DEVELOPMENT REVIEW BOARD PANEL A AGENDA

2. [Resolution No. 447. Spring Terrace Tract A Open Space. The applicant is requesting approval of a site design review for site improvements in the Tract A Open Space in the Spring Terrace Subdivision](#)

[DB26-0002 Spring Terrace Tract A Open Space](#)

Exhibit A1
Staff Report
Wilsonville Planning Division
Site Design Review of Tract A Open Space
Spring Terrace Subdivision

Exhibit A
Tract A Civil Plan

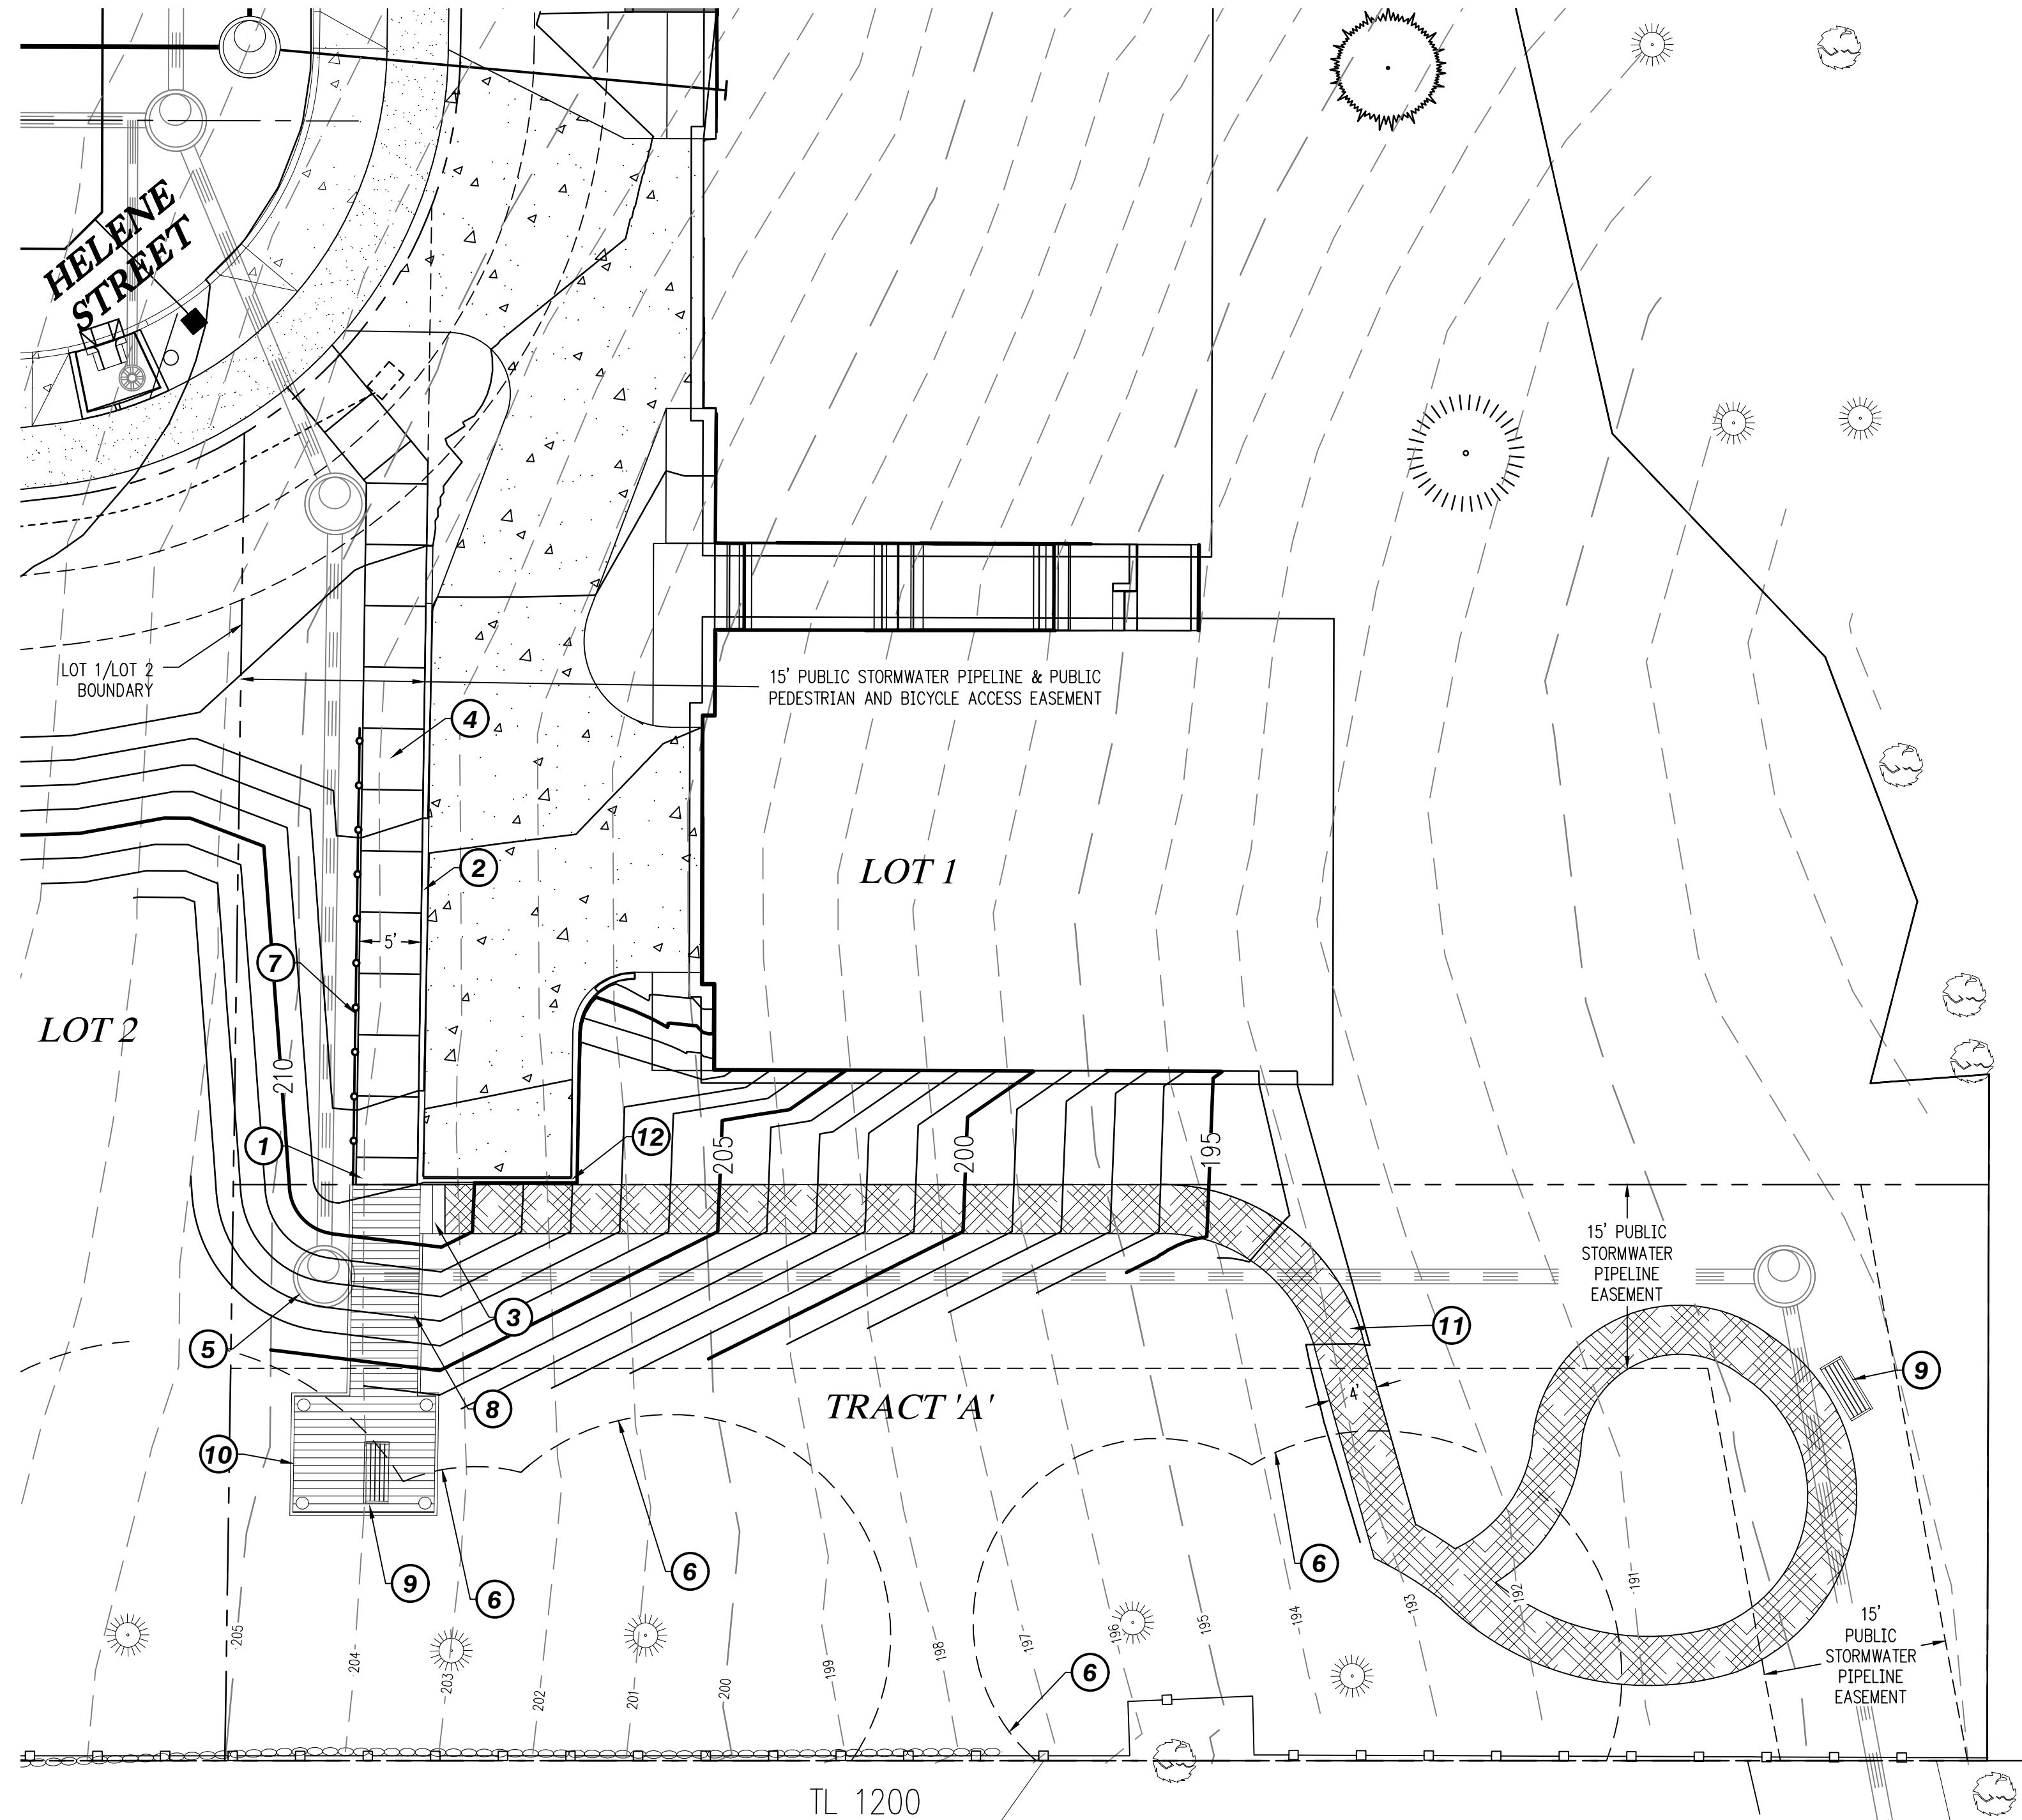
- Accessibility: Will the viewing platform and its approaches utilize smooth, non-slip surfaces with a slope no greater than 5%? Does the overall plan meet ADA requirements?

Exhibit F
Landscape Plan for Tract A

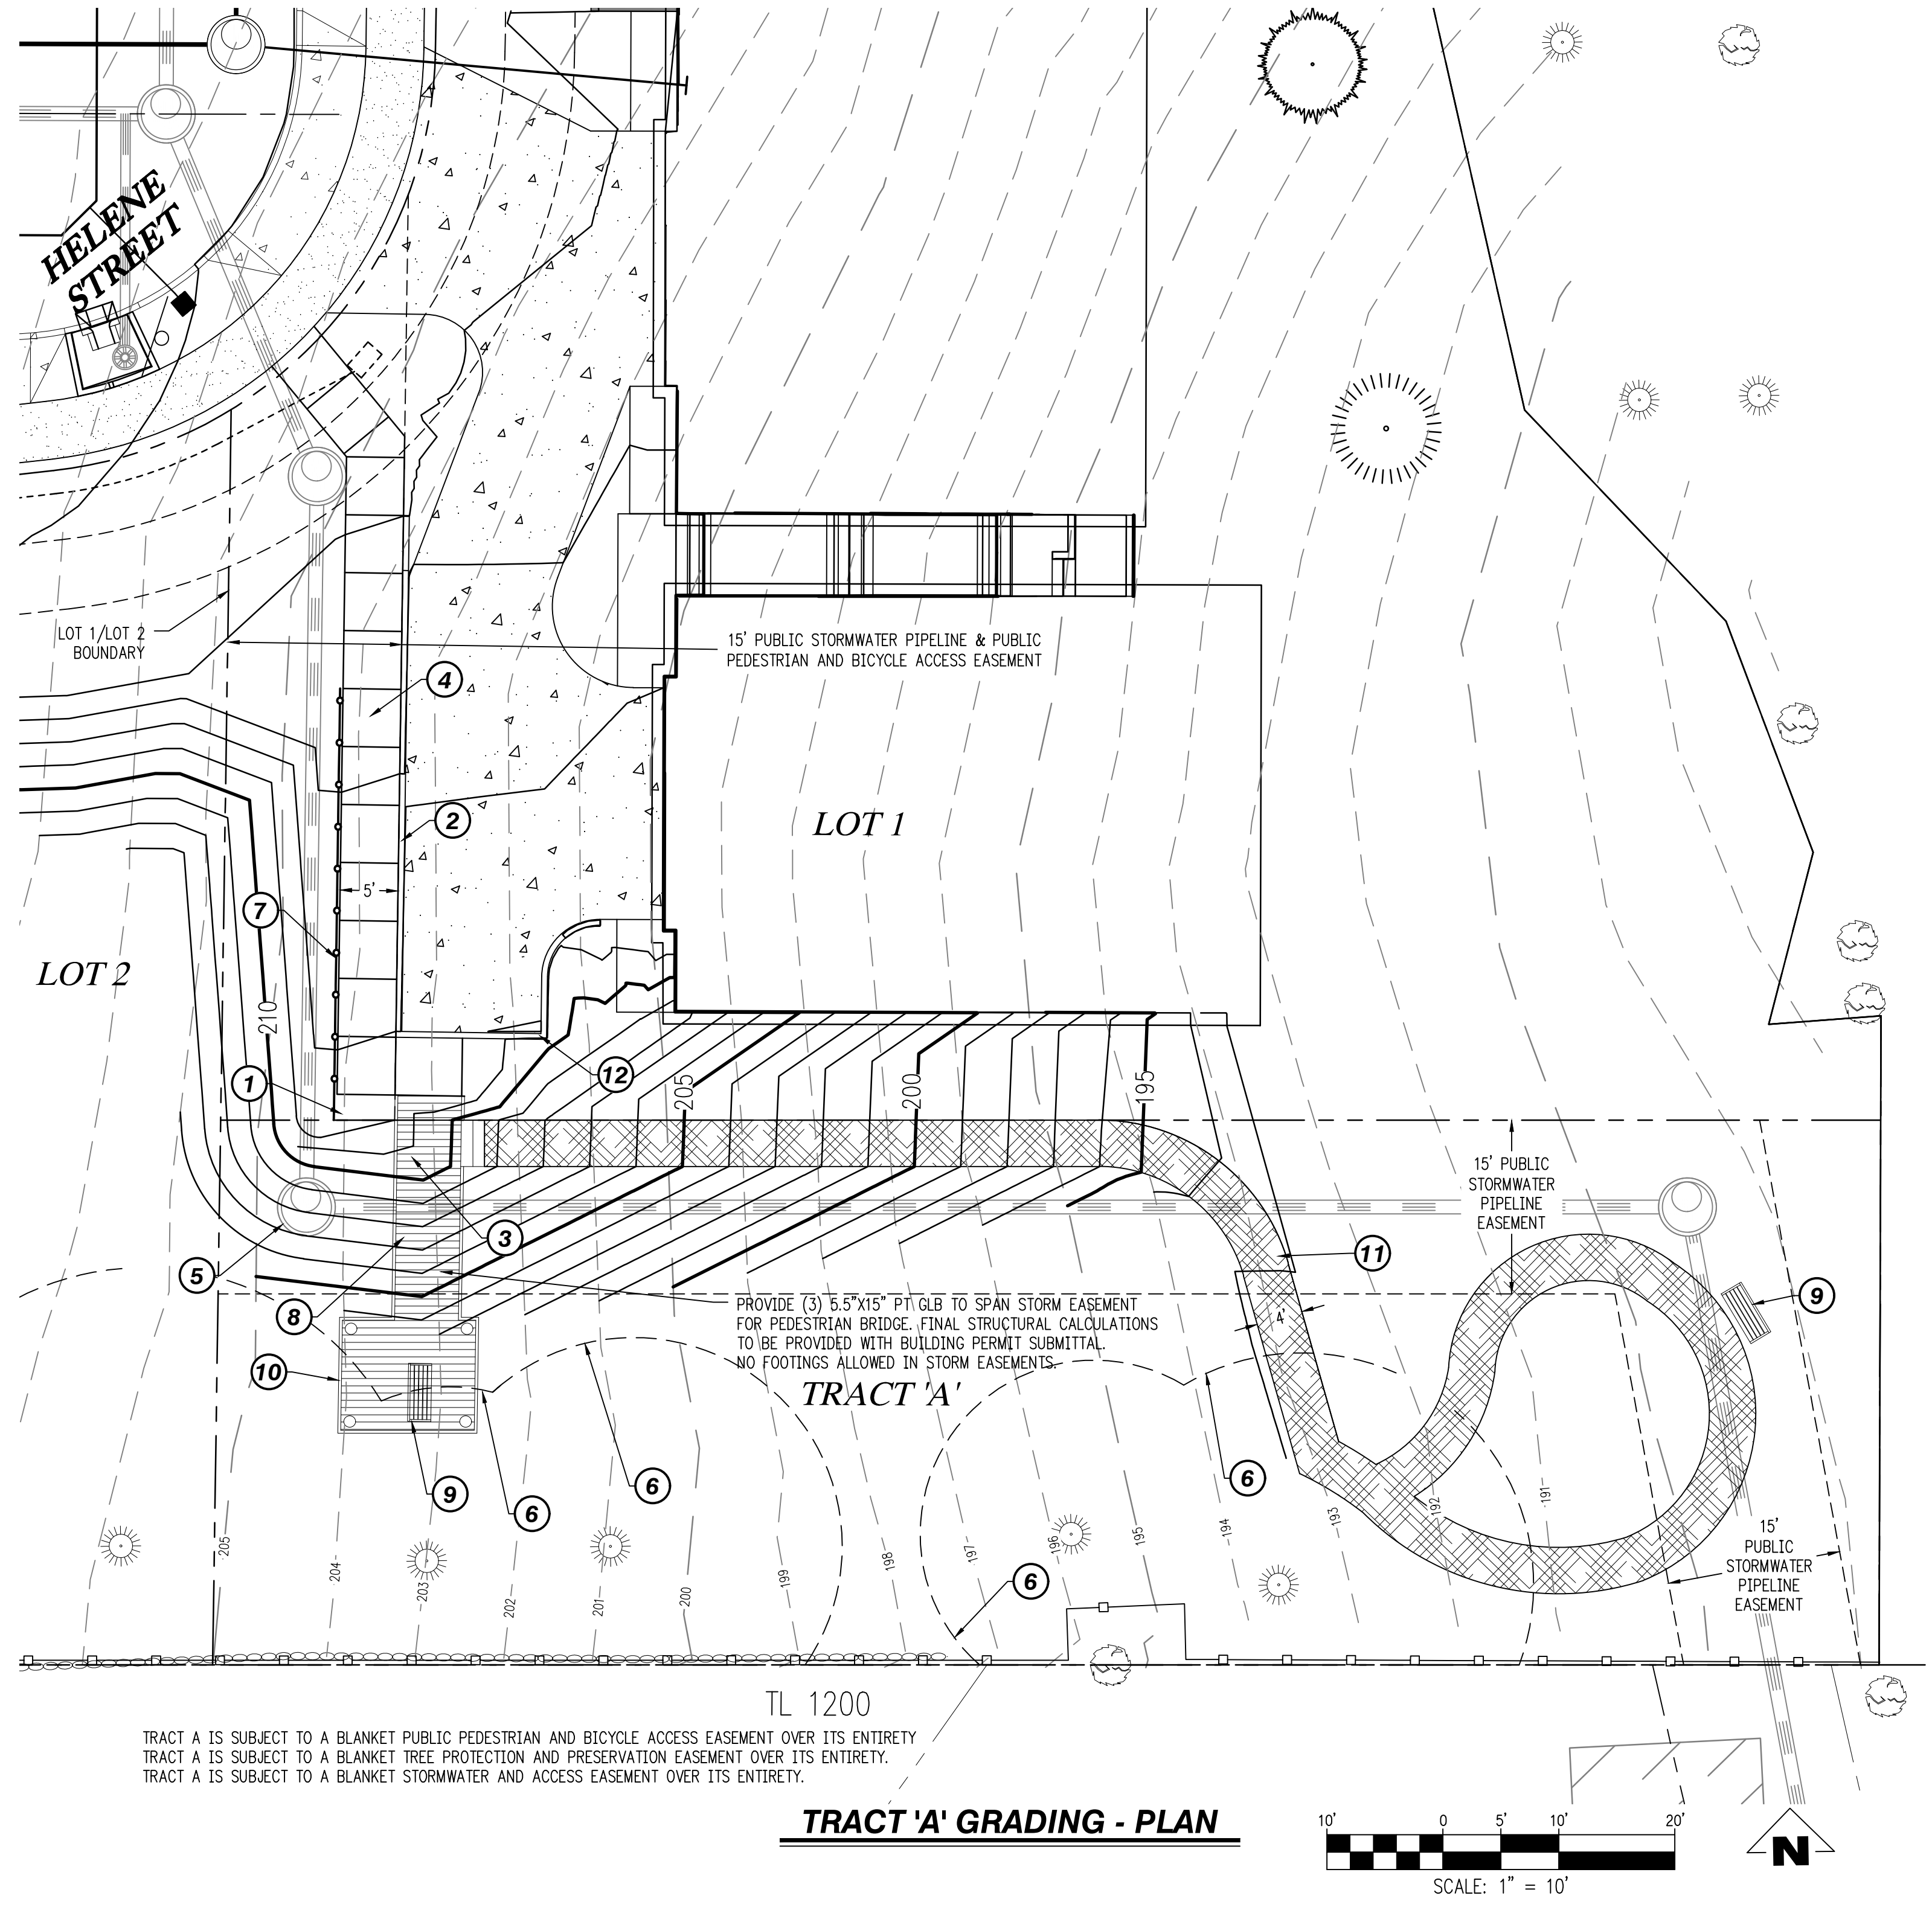
There is no legend listing what is being planted and what size these trees or shrubs(?) will be.

The viewing platform seems an unnecessary addition. We as neighbors are not in favor of a platform that looks directly into our backyards. Why is this platform included? How tall will this platform be? What material is being used? Does it have railings? The site plan is lacking helpful information.

- Landscaping: What size will the Crabapple and Wax Myrtle trees be at the time of planting? Given that Crabapples grow 1-2 feet per year, I am concerned about the privacy of homes along the property line if mature trees are not used. There will be a condition of approval ensuring that all trees planted comply with Code requirements regarding minimum tree size.

- Clarity of Plans: The copy of the Tract A plan mailed to residents lacks a clear legend and is difficult to follow. Please see the note above about the upcoming publication of the staff report and where to access it.

After reviewing the site plan, I have a major concern regarding the proposed pedestrian path and platform. I understand that it must be ADA compliant, but not at the cost of further sacrificing my privacy that I lost when the trees along the property line were cut down.

- Amenities: Does the plan include the installation of tables? No tables are proposed, but three benches are proposed in the area.
